## Memorandum to the City of Markham Committee of Adjustment March 14, 2025

File:	A/006/25
Address:	365 Hood Road, Markham
Agent:	API Development Consultants Inc. (Natalia Garavito)
Hearing Date:	Wednesday, March 19, 2025

The Applicant is requesting relief from the following requirements of the "Employment – Business Park (EMP-BP)" zone under By-law 2024-19, as amended, as it relates to a proposed 15-storey hotel. The variances requested are to permit:

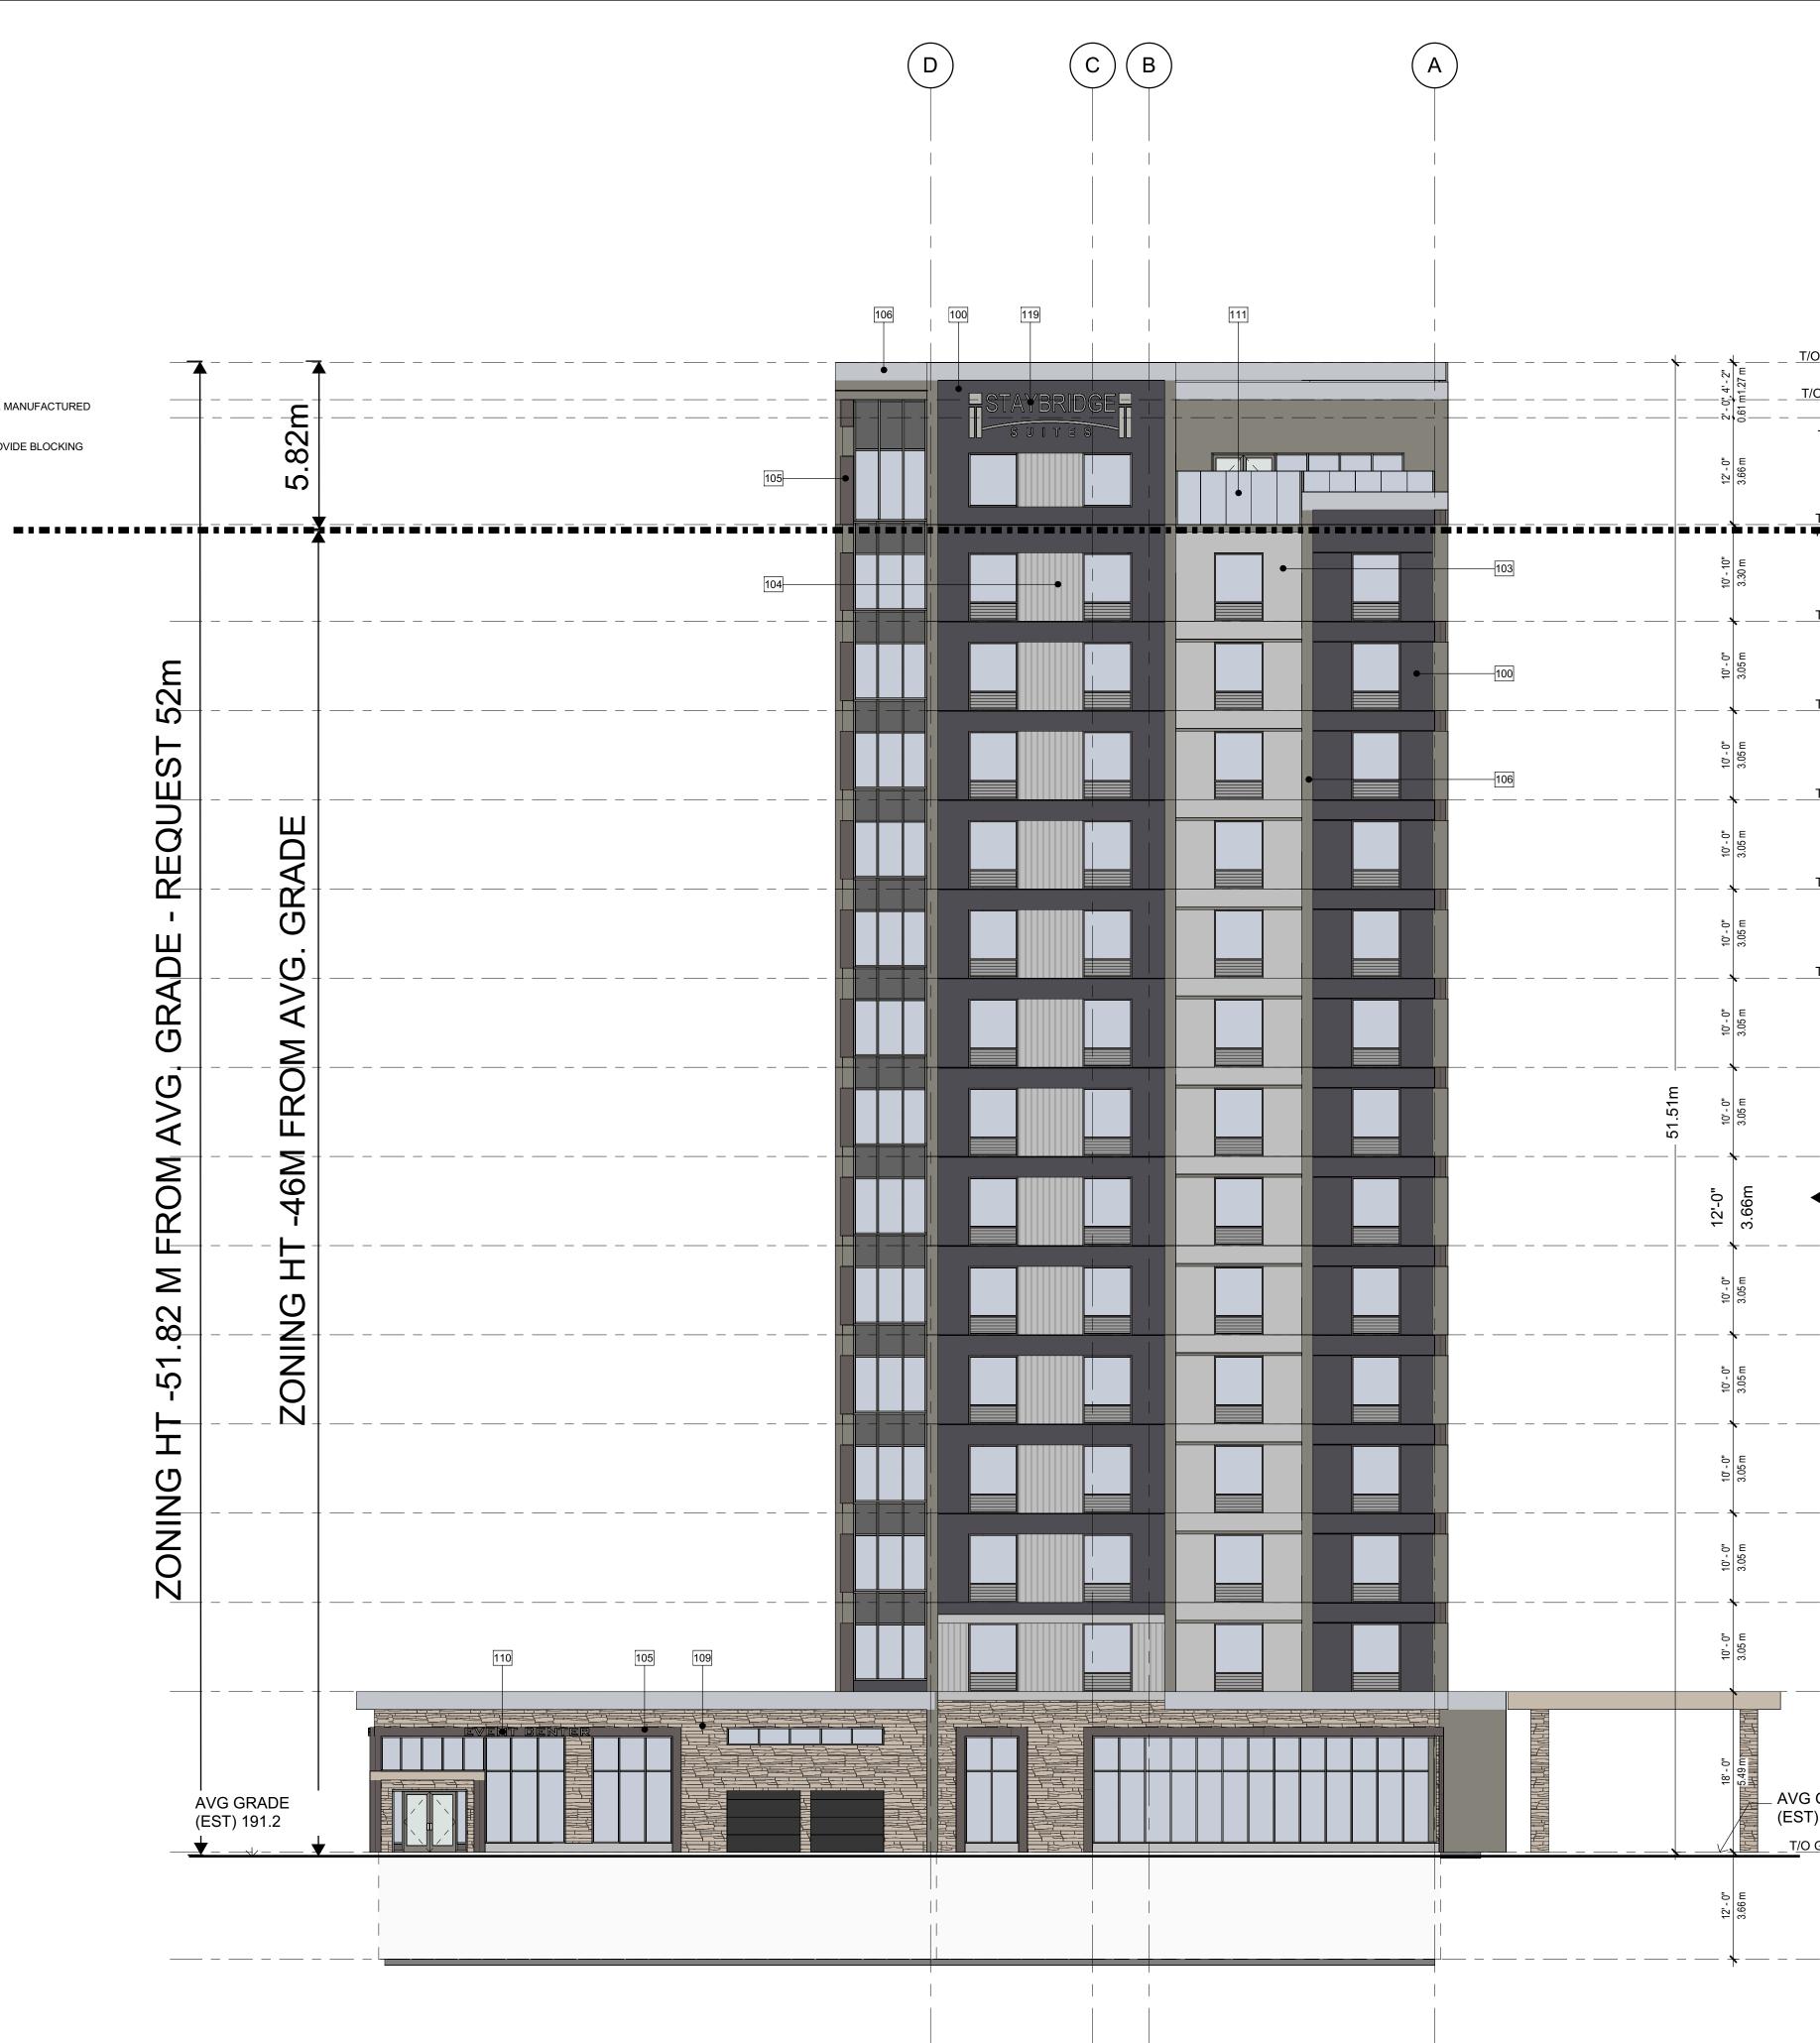
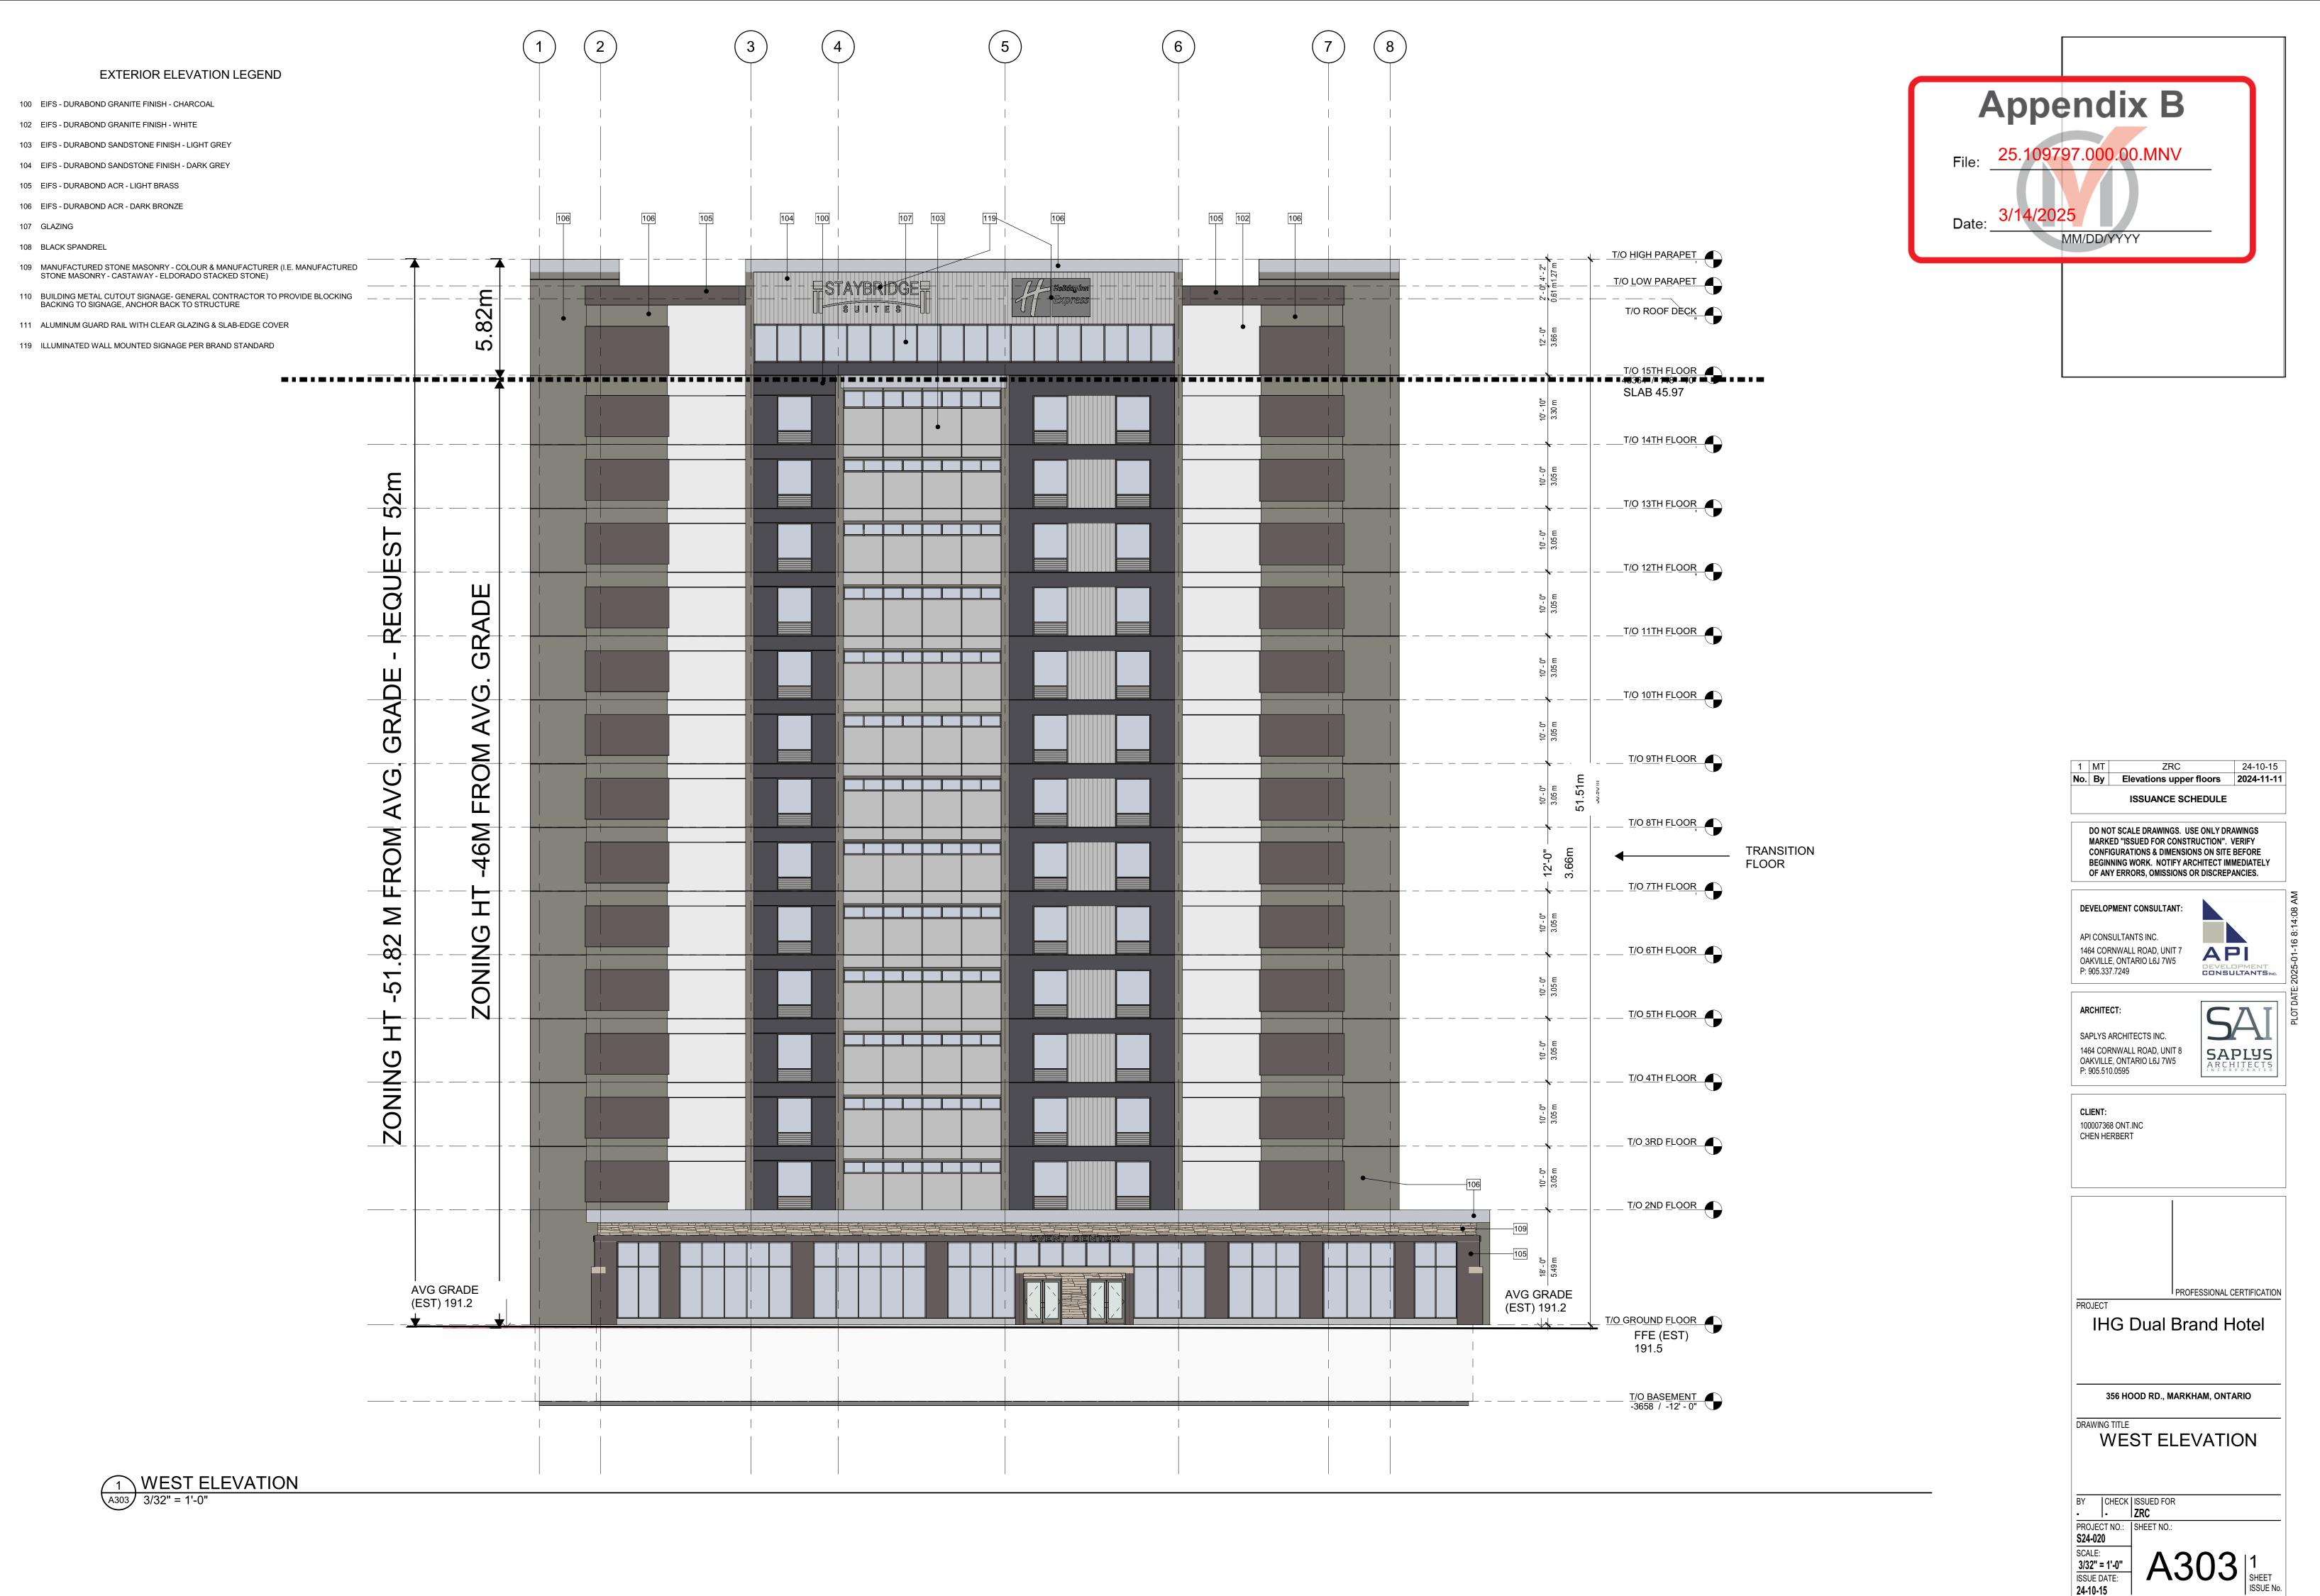
The Applicant is requesting relief to permit a maximum building height of 52 m (170.6 ft) above grade, whereas the By-law permits a maximum building height of 46 m (150.9 ft) above grade. This represents an increase of 6 m (19.7 ft) or 13% greater than the By-law requirement.

The requested variance is to facilitate the 15<sup>th</sup> storey of the proposed development and the rooftop terrace/amenity floor. As existing developments in the immediate surrounding are generally industrial/ commercial office uses, Staff are of the opinion that the proposed height increase will not cause any adverse impacts on neighbouring properties. Therefore, Staff considers the variance sought on the maximum building height to be minor in nature and have no objection.
